Bulletin No. 2004-07

## Installation of Neoprene Wrap 1.5 L OptiMax

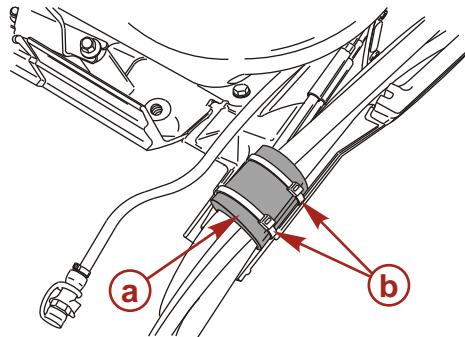
The control cables, harness, fuel hose, etc. have a neoprene wrap placed around them where they enter the bottom cowl. If the neoprene wrap does not fit tightly enough, it may be drawn or sucked into the power head compartment, ending up in front of the reed valves or throttle plate, restricting the air flow. The restriction can result in a loss of top RPM, spark plug fouling, engine stalling, or a no start condition.

Position the neoprene wrap as shown in the sketch below and place 2 cable ties around the neoprene wrap to hold it in place. Install the cable ties near the front and rear edge of the neoprene wrap.

**a** - Neoprene wrap

**b** - Cable ties (2)
